# YOST GRUBE HALL ARCHITECTURE

# Addendum 1

То:	Megan Finch, Beaverton School District
From:	Allison Miller
Project:	BSD – Raleigh Park HVAC and Electrical Upgrades YGH Job #19-0012
Subject:	Addendum 1
Date:	16-March-2020

#### SHEET A3.02 – LIBRARY ENLARGED PLANS

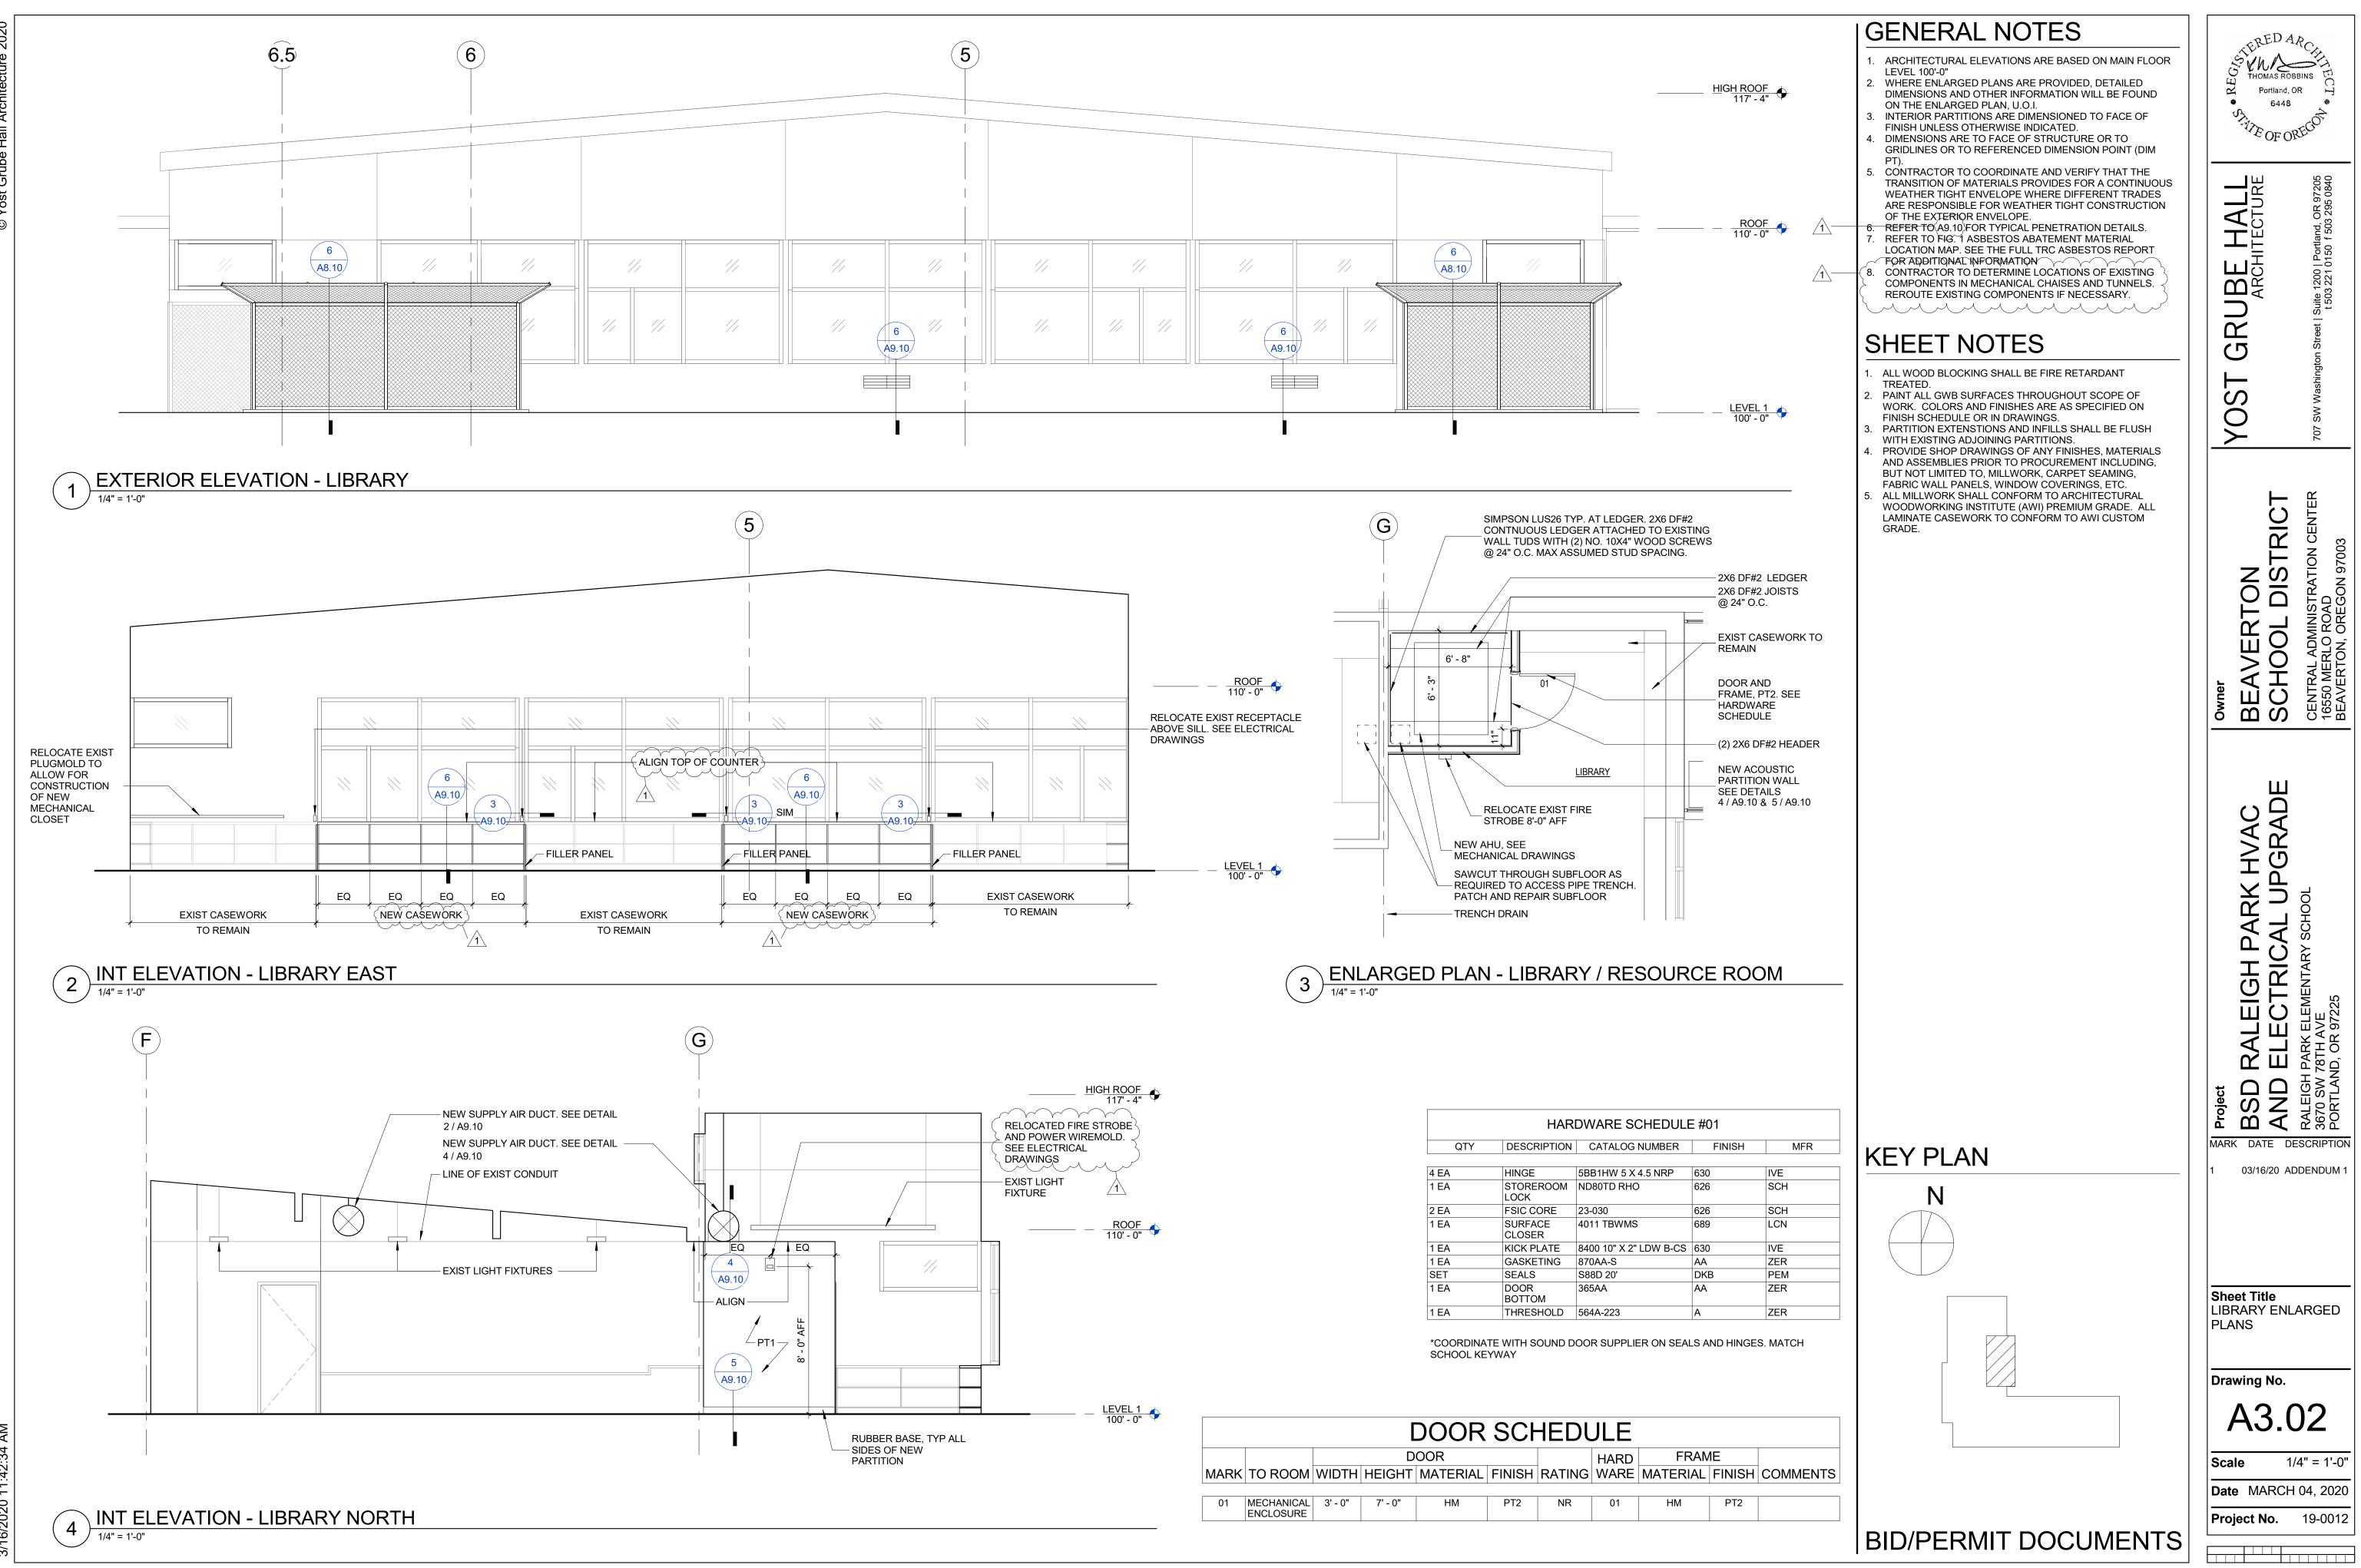
**REVISE** detail 2 to clarify locations of new and existing casework. Also, note added to clarify design intent to align the top of new and existing casework counter tops

**REVISE** detail 4 to clarify relocation of existing fire alarm strobe and power wire mold in library (previously only called out from electrical drawings)

## SHEET E4.01 - ELECTRICAL SCHEDULES & DETAILS

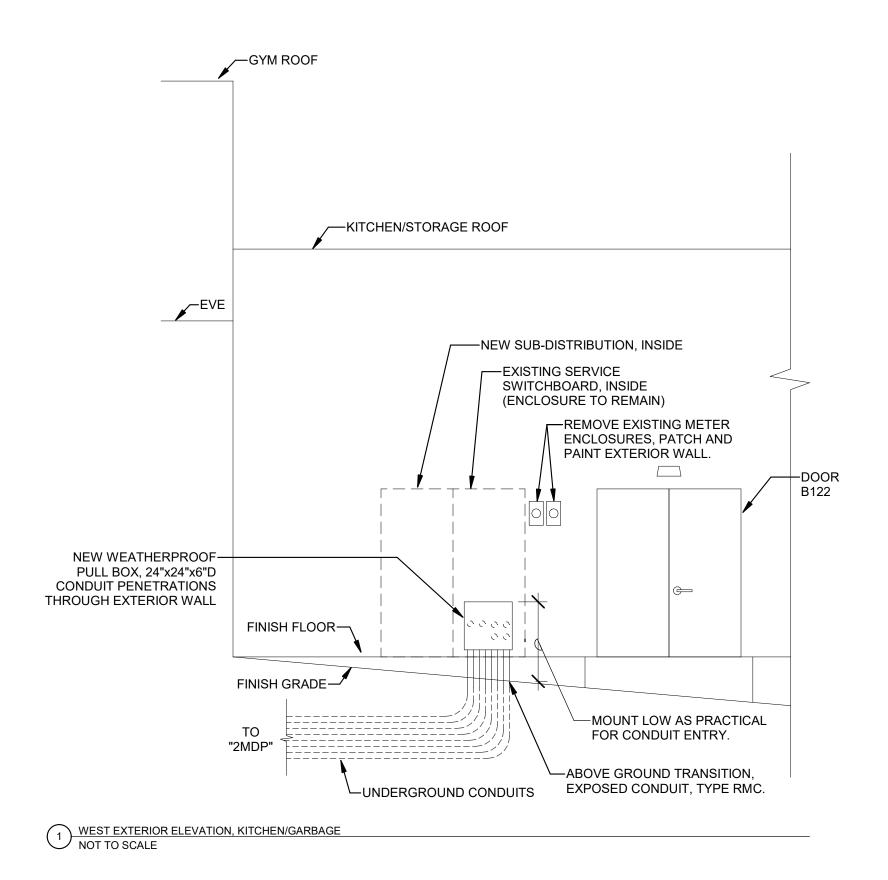
**REVISE** detail 2 to coordinate with and reference the new geotechnical report attached to this addendum regarding excavation, compaction, and backfill recommendations for the conduit trench

Utility trenches may encounter seasonal perched ground water seepage although flow rates are expected to be modest in the low permeability soils. Shoring of utility trenches will be required for depths greater than 4 feet and where groundwater seepage is present. We recommend that the type and

Pipe bedding must be installed in accordance with the pipe manufacturers' recommendations. If groundwater is present in the base of the utility trench excavation, we recommend overexcavating the trench by 12 inches and placing trench stabilization material in the base. Trench stabilization material must consist of well-graded, crushed rock or crushed gravel with a maximum particle size of 4 inches and be free of deleterious materials. The percent passing the U.S. Standard No. 200 Sieve must be less than 5 percent by weight when tested in accordance with ASTM C 117.

Trench backfill above the pipe zone must consist of well graded, angular crushed rock. Crushed recycled concrete, or sand fill with no more than 7 percent passing a #200 sieve. Trench backfill must be compacted to 92 percent relative to ASTM D-1557, and construction of hard surfaces, such as sidewalks or pavement, must not occur within one week of backfilling. The preceding trench backfill will provide suitable subgrade support for asphalt concrete and base rock pavements with thicknesses designed for bus traffic.
